CATAWBA NUCLEAR STATION, UNIT NOS. 1 AND 2  
DOCKET NOS. 50-413 AND 50-414  
RENEWED LICENSE NOS. NPF-35 AND NPF-52

**SUBJECT: RESPONSE TO NRC REQUEST FOR ADDITIONAL INFORMATION (RAI)  
RELATED TO A LAR TO REVISE THE UPDATED FINAL SAFETY ANALYSIS  
REPORT TO REFLECT ELECTRICAL POWER SYSTEM ALIGNMENTS FOR  
SHARED SYSTEMS**

**Response to NRC Request for Additional Information**

**Figure 1: Unit 1 "A" Train 4160VAC Electrical Power System**

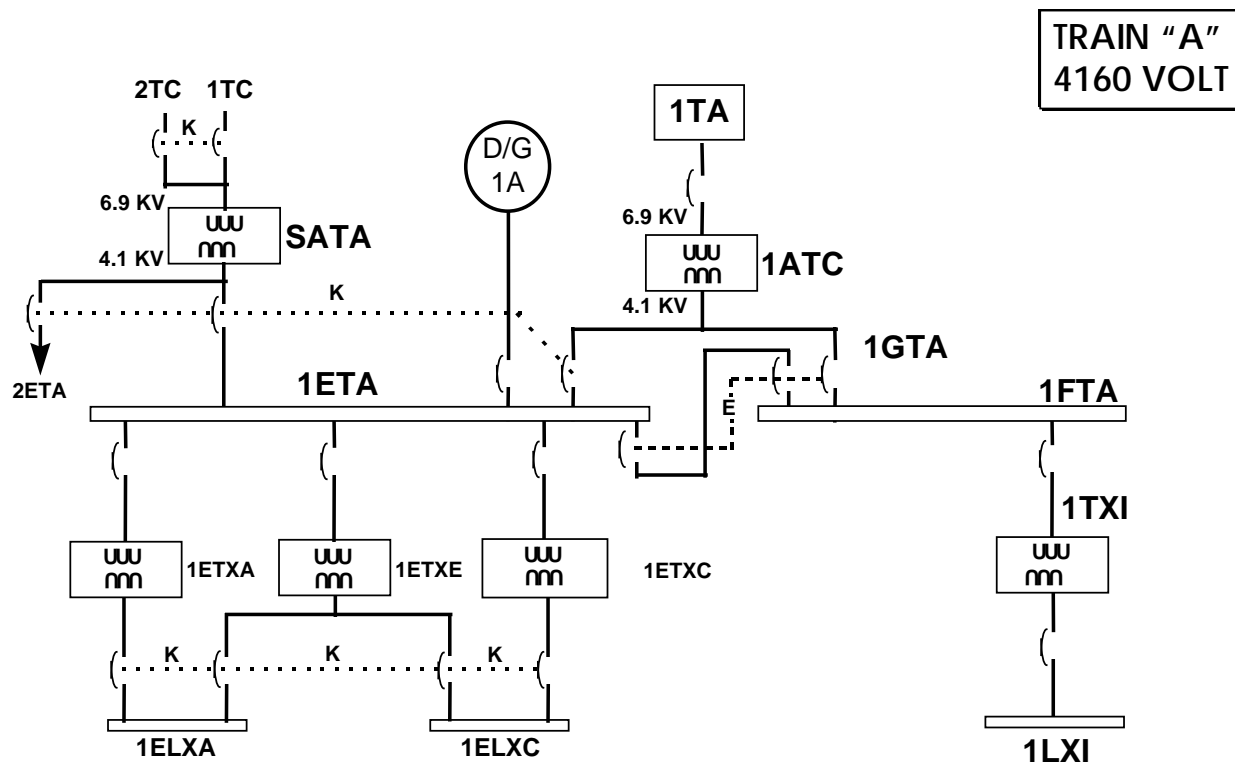
With a single line diagram, please explain how the electrical systems for each unit (power sources (both alternating current (ac) and direct current (dc), ac medium voltage buses and switchgears, distribution panels, load centers, motor control centers, and shared loads) are configured. For the following operating configurations, please identify (1) the applicable electrical-related technical specification (TS) requirements for each unit; (2) the operability of each shared structure, system, and component (SSC) (i.e., nuclear service water system (NSWS), control room area ventilation system (CRAVS), control room area chilled water system (CRACWS), and the auxiliary building filtered ventilation exhaust system (ABFVES)); and (3) the applicable TS required actions:

Figures 1 and 2 below show the 4160v and 600v electrical power systems for CNS Unit 1 A train. Unit 2 A train and both Unit 1 and 2 B trains are similar, with the exception being the shared 600v motor control center 2EMXH. Motor control center 2EMXH would be in the same location as 1EMXG on the B train. Normally 1EMXG is powered from Unit 1 A train via load center 1ELXA and 2EMXH is powered from Unit 2 B Train via load center 2ELXB. 1EMXG can also be powered from Unit 2 A train via load center 2ELXA and 2EMXH can be powered from Unit 1 B train via load center 1ELXB.

- b. Referencing Figures 1 and 2 provided in the response to RAI 5, the units are electrically separated by use of interlocks to prevent the units from being electrically tied together. CNS employs several Kirk Key Interlock schemes that allow only one circuit breaker to be closed at a time using "break-before-make" procedural actions. The ESF testing alignment requires CNS to power the shared 600v MCCs 1EMXG and 2EMXH from the essential bus undergoing the ESF test. For example, Unit 2 essential bus 2ETA undergoing ESF testing would require 1EMXG ("A" train) to be aligned to 2ETA via load center 2ELXA. Shared MCC 1EMXG would be transferred to 2ELXA via a procedure that would de-energize 1EMXG by separating power from load center 1ELXA, and then re-energize 1EMXG from 2ELXA. Unit power separation is maintained at all times.
